Access Compliance Report

Public Rights-of-Way

| Intersection ID: 28291 | Main Street: COMMUNITY HOUSE RD | Cross Street: ARDREY KELL RD | Location: N |
| ADA ID: 2FACD147A1C6 | Ramp Type: Para | Initial Pass/Fail: Fail | Overall Compliance: No |

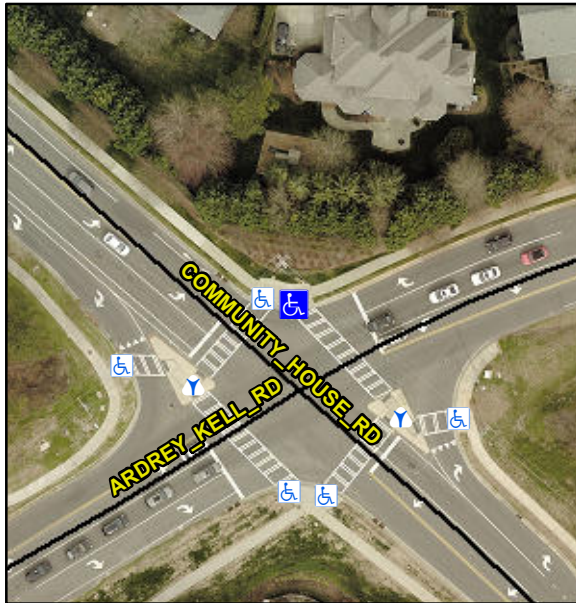
R304.5.3, R304.3.2

| Compliance | Description | Data | Compliance | Description | Data |
|------------|----------------------|-------|------------|-----------------------------|------|
| Yes | Ramp Slope LT (%) | 6.5 | No | Ramp Slope RT (%) | 9.0 |
| No | Ramp XSlope LT (%) | 4.2 | Yes | Ramp XSlope RT (%) | 1.0 |

Remove & Replace Entire Ramp.
